**STAFF REPORT: DECEMBER 10, 2025 MEETING**

**APPLICATION NUMBER: HDC2025-00495**

**ADDRESS: 899 EDISON STREET**

**SCOPE: DEMOLISH TWO-STORY REAR WING, ERECT TWO-STORY REAR WING**

*Proposed elevations for the new construction, from applicant's materials.*

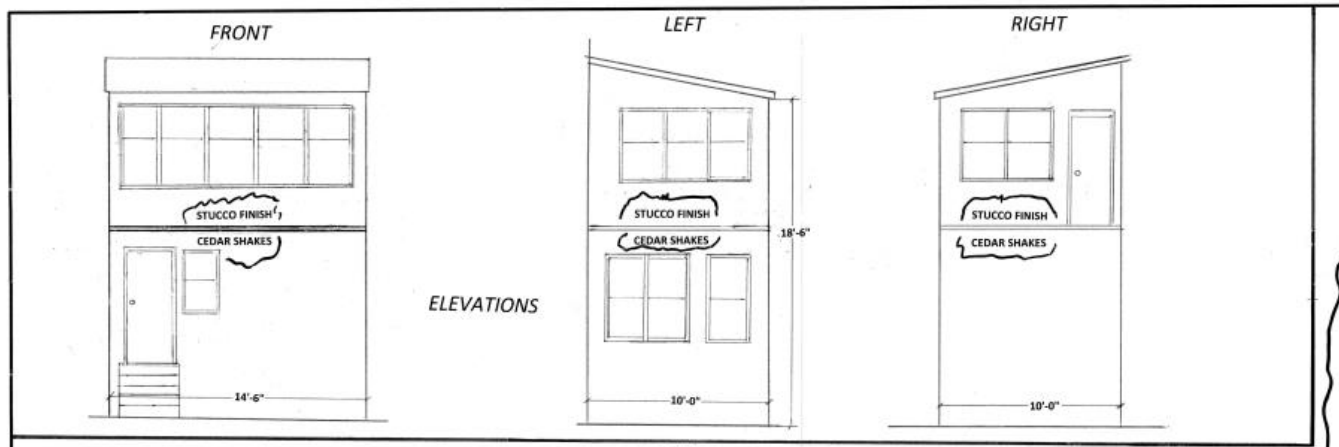
- However, it is staff’s opinion that the submitted elevation drawings are not sufficiently detailed to fully understand complete construction details. They also don’t show how windows will sit within the wall planes and how window trim will look when finished. Staff shared an example with the applicant of more detailed architectural drawings, but more detailed drawings for this proposal were not provided.

- The character-defining deep eave of the historic addition is proposed to be eliminated in the new construction.
  - Roof product specifications were not provided.

- Overall, if the commission finds that the rear two-story wing is beyond repair, staff finds that the proposal to replicate the existing to be largely in line with the Standards, Guidelines, and Elements of Design. However, as noted above, the submitted elevation drawings are not sufficiently detailed to fully understand complete construction details. In addition, the deep overhang at the roof above the second floor is a character-defining feature, and if the rear addition is being replicated according to Standard 6, that overhang should be replicated as well.

- The proposed new construction's plans are not sufficiently detailed to fully understand exactly how the finished new addition would look.
- Staff is unclear if it is feasible to install the existing historic windows at the new wing's second story per the proposal. If their preservation and reuse is not feasible, product specifications for new windows would need to be approved by the Commission. Product specifications for the first-floor windows are needed as well.
- The design for the new addition eliminates the deep overhang of the historic eaves. If the historic feature (the two-story rear wing including the rear porch and the sleeping porch) is being replicated according to Standard 6, the historic, character-defining deep eaves should be replicated as well.

- The new design eliminates the deep eave which is a character-defining feature of the historic addition.
- The submitted drawings are not sufficiently detailed to fully understand complete construction details of the new proposed new addition. Therefore, it is has not been clearly established the proposed new wing would adequately match the existing.
